21 May 2009
08 5071 90301.L02/V.1

**WASTE LICENCE APPLICATION (W0267-01)
HI-VOLT IRELAND LIMITED**

Client: **HI-VOLT IRELAND LTD.** Title: **FACILITY LAYOUT PLAN (Existing and Proposed Infrastructure)**

Project: **WASTE LICENCE APPLICATION**

Figure
WLA-04

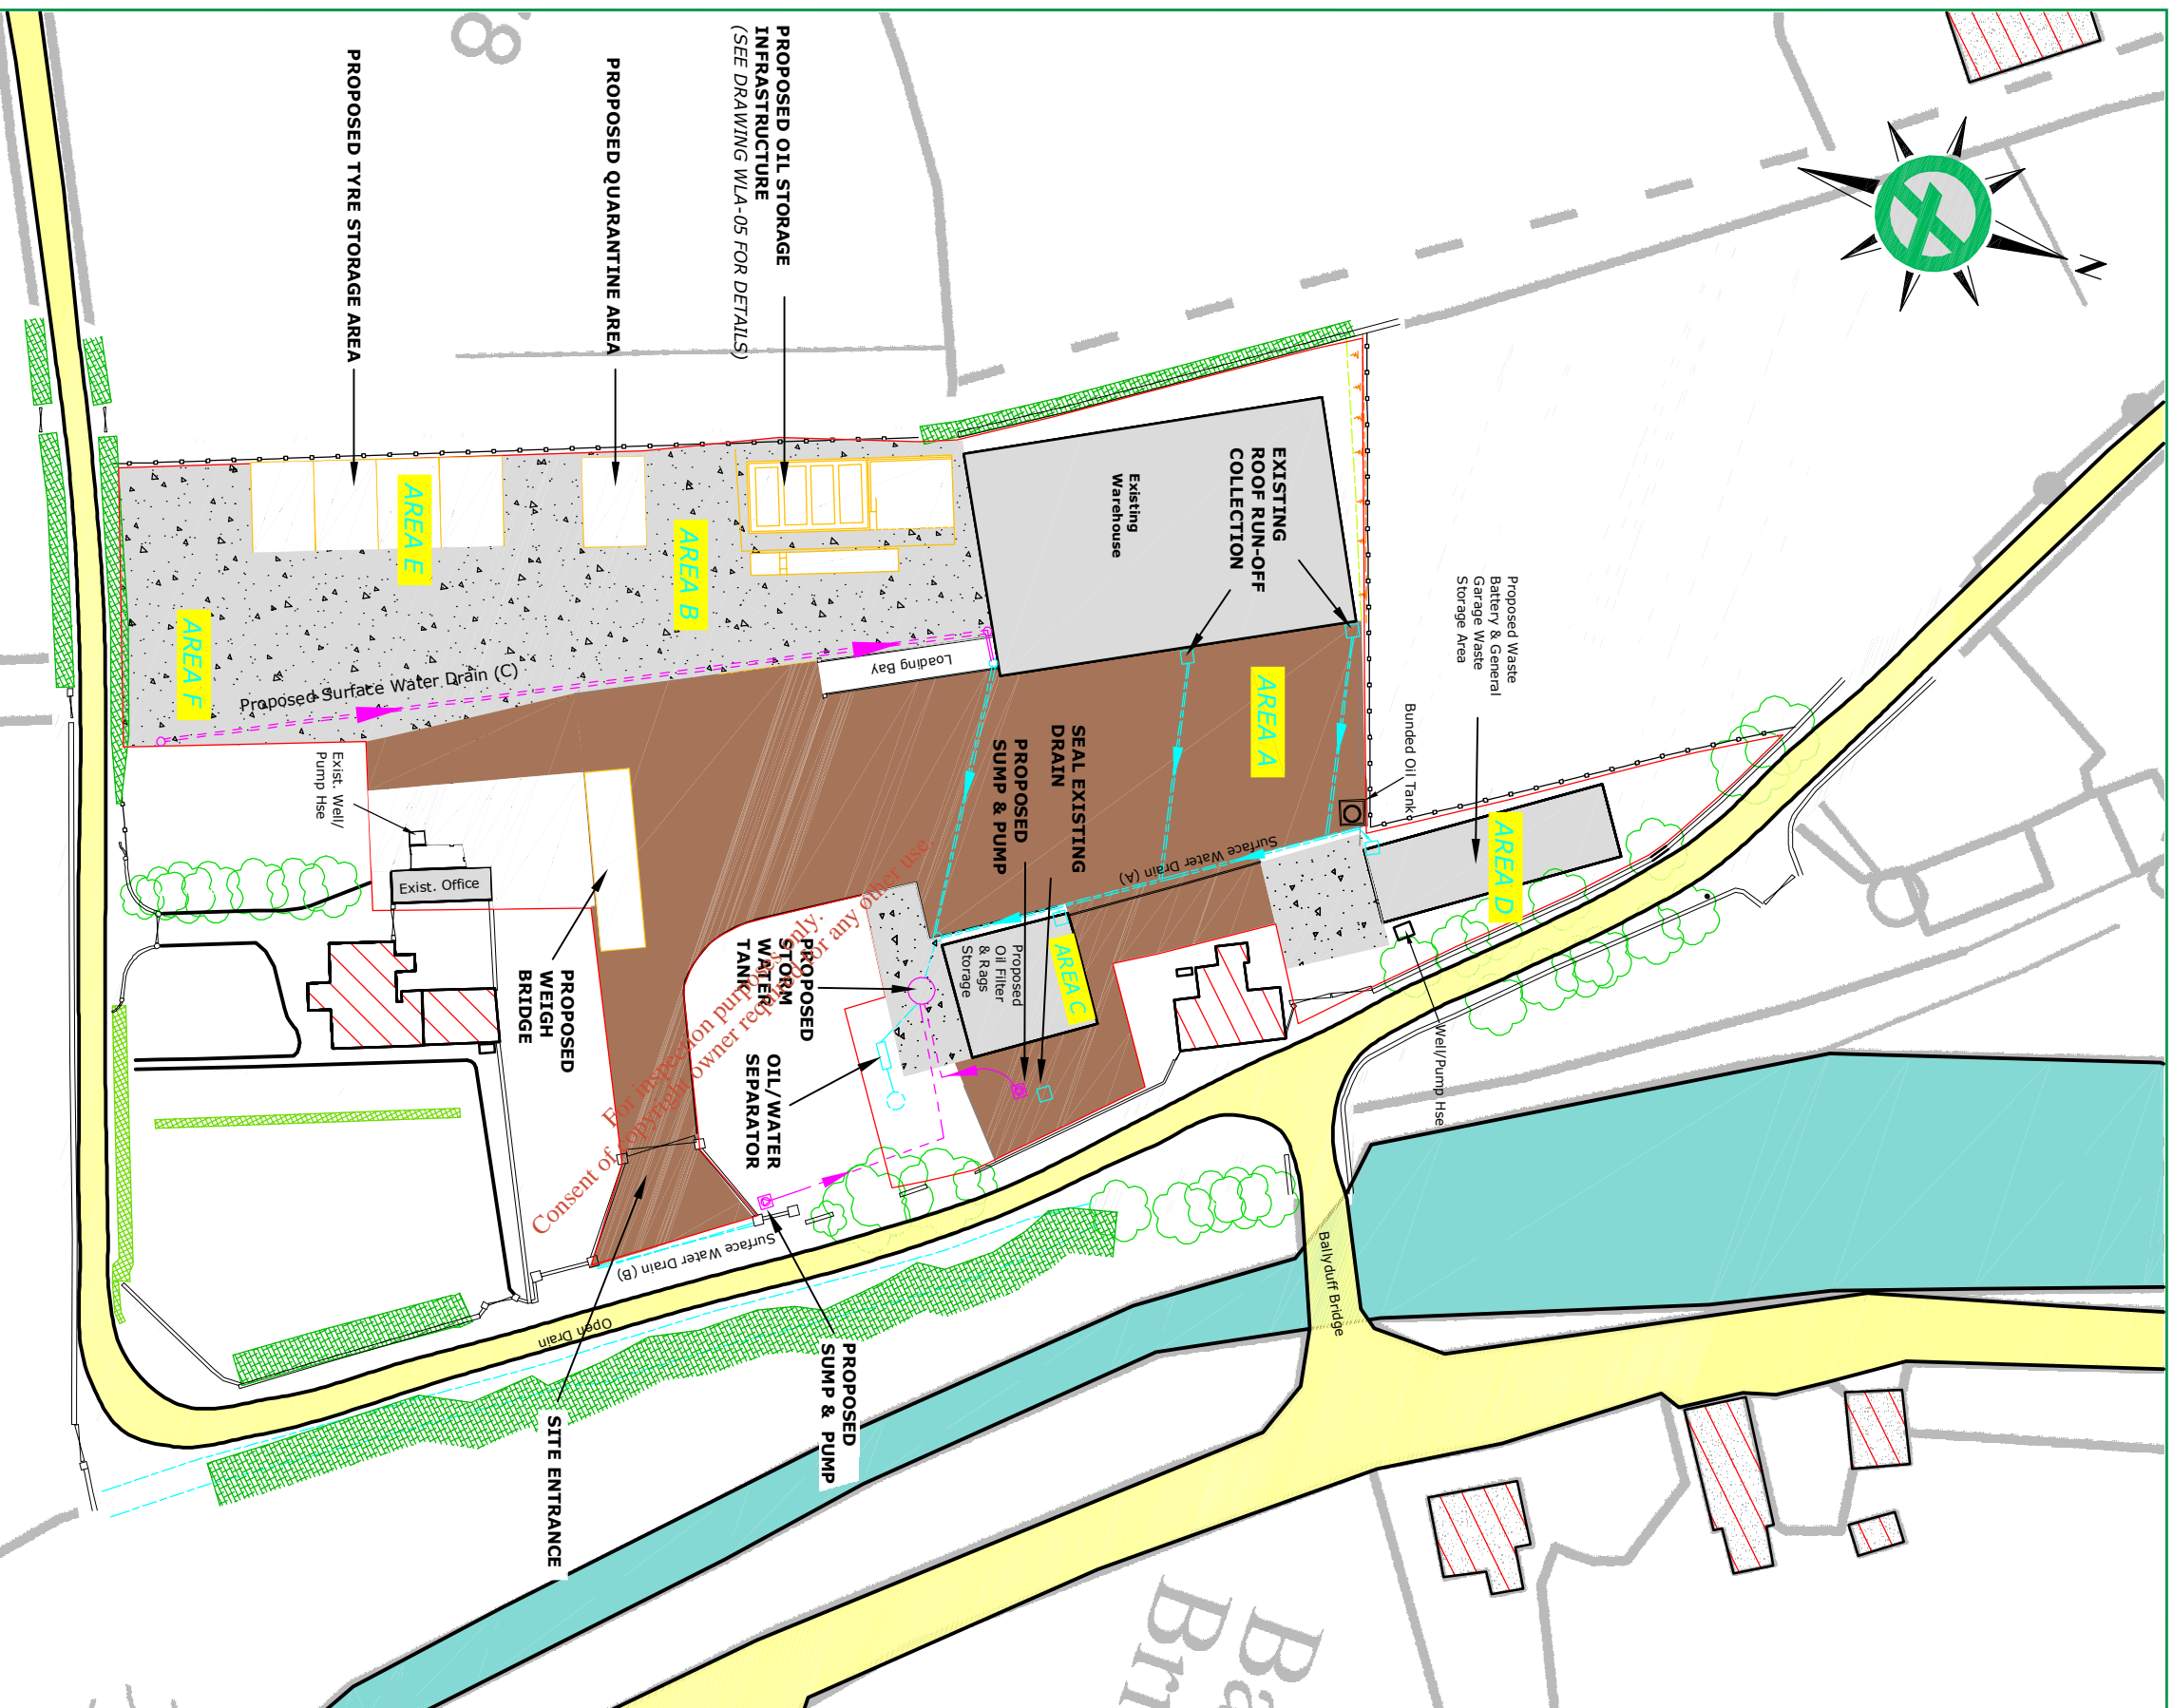
Please confirm that no water is required for facility processes.

Please clarify plans for the management of storm water (including roof water) onsite. Including in your response a time schedule for completion of any works necessary.

We can confirm that the proposed facility will **not** require any water for the facility process.

Please see the attached revised attachments E.2 and E.4, outlining the Storm Water Management Plan and the associated revised Drawing WLA-04, Rev B. The Non-Technical Summary has also been updated to reflect these changes and a schedule for the completion of proposed works for the storm water management has been included.

- Storm water from Area A will drain into the existing Drain A. The existing roof runoff is collected and directed into Drain A;
- Storm water from Area B, Area E and Area F will drain into proposed Drain C. This will be collected by the proposed storm water tank and directed into the oil/water separator; and
- Run-off from yard area (west of to Area C) as shown on Drawing WLA-04, Rev B, will be collected in a new sump from where it is pumped to the storm water tank ahead of the oil interceptor. The existing drain in this area is proposed to be sealed. Run-off from site entrance is captured in surface water drain B (Drawing WLA-04, Rev B), it is proposed to pump this water to the storm water tank. Both proposed pumps will be level controlled.
